CPP-45 Series DISCONTINUANCE

We would like to inform you that we will stop production of CPP-45 Series. For aging of production facilities and decreasing environmental load substances during production process, the production method of conductive plastic element will be changed from Co-mold to screened printed.

MIDORI PRECISIONS CO., LTD.

Outer Dimension

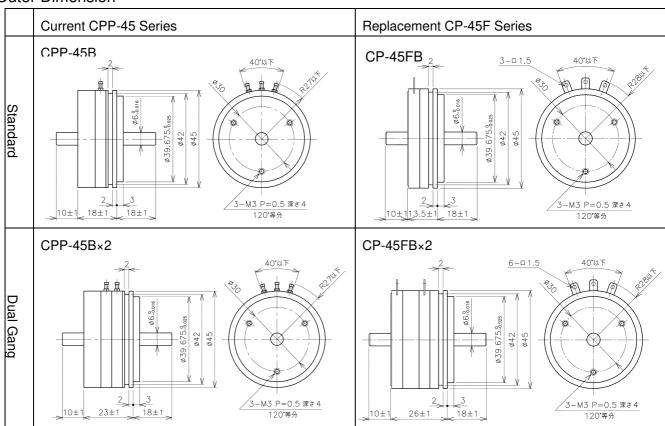
- (1) CP-45F Series are compatible with a fitting pitch of CPP-45 Series. However outer dimension has been changed. For details, please refer our catalog.
- (2) Standard Independent Linearity of CP-45F Series is +/-0.1%. +/-0.1% is special linearity of CPP-45 Series. (Standard Independent Linearity is +/-0.3%)
- (3) Total resistance value is available all range of CPP-45 Series.
- (4) Center Tap Option will be available accordingly.
- (5) Replacements for Custom models CPP-45 Series will be consulted separately.

- CP-45FRBN and CPP-45-xxLS will not be changed outer dimension.
- CP-45F-xxSX will be changed Potentiometer part only.
